Access Compliance Report

Public Rights-of-Way

Intersection ID: 53880	Main Street: PAWTUCKETT_RD	Cross Street: PAW_VILLAGE_RD	Location:	S
ADA ID: 450425FB0AA8	Ramp Type: Perp	Initial Pass/Fail: Fail	Overall Compliance: No	Severity Score: 10

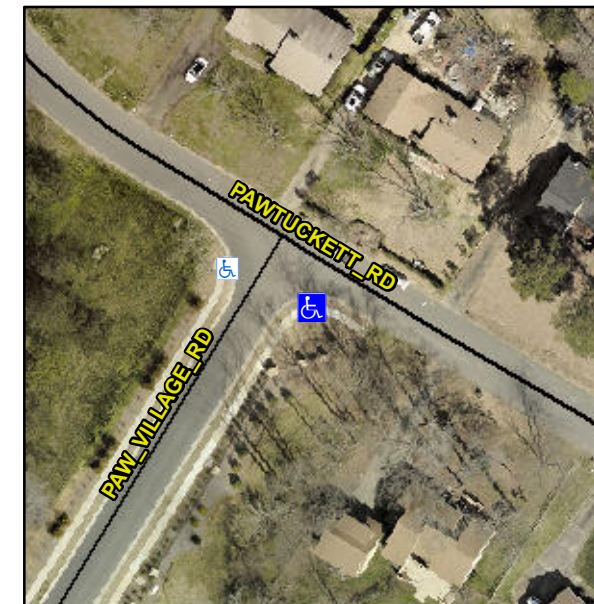
R304.5.1, R304.5.3

Compliance	Description	Data	Compliance	Description	Data
N/A	Ramp Length (in)	47.0	Yes	Ramp Slope (%)	5.6
No	Ramp Width (in)	45.0	No	Ramp XSlope (%)	3.1
N/A	Flare Type LT	N/A	N/A	Flare Type RT	N/A
N/A	Flare Slope LT (%)	N/A	N/A	Flare Slope RT (%)	N/A
N/A	Flare Traversable LT?	N/A	N/A	Flare Traversable RT?	N/A
N/A	Landing Length (in)	N/A	N/A	DWS Provided?	N/A
N/A	Landing Width (in)	N/A	N/A	DWS Contrast?	N/A
N/A	Landing Slope (%)	N/A	N/A	DWS Length (in)	N/A
N/A	Landing X Slope (%)	N/A	N/A	DWS Full Width?	N/A
N/A	Landing Curb? (Y/N)	N/A	N/A	DWS Offset (in)	N/A
N/A	Shared Landing?	N/A			
N/A	Gutter Ponding?	N/A	N/A	Gutter Slope (%)	N/A
N/A	Gutter Lip Ht (in)	N/A	N/A	Gutter X Slope (%)	N/A
N/A	Painted X Walk1?	No	N/A	Painted X Walk2?	N/A
	X Walk 1 Direction	To NW		X Walk 2 Direction	N/A
N/A	X Walk 1 Width (in)	N/A	N/A	X Walk 2 Width (in)	N/A
	X Walk 1 Slope (%)	5.7		X Walk 2 Slope (%)	N/A
	X Walk 1 X Slope (%)	0.2		X Walk 2 X Slope (%)	N/A

Remove & Replace Entire Ramp.
